Product Change Notice (PCN)

PCN Number: PCN-0450214R

SD-SN series

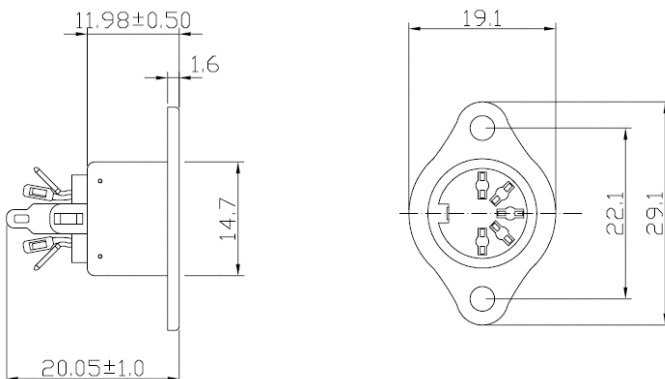
Mechanical dimension changes to connector housing:

Old Housing Dimensions

New Housing Dimensions
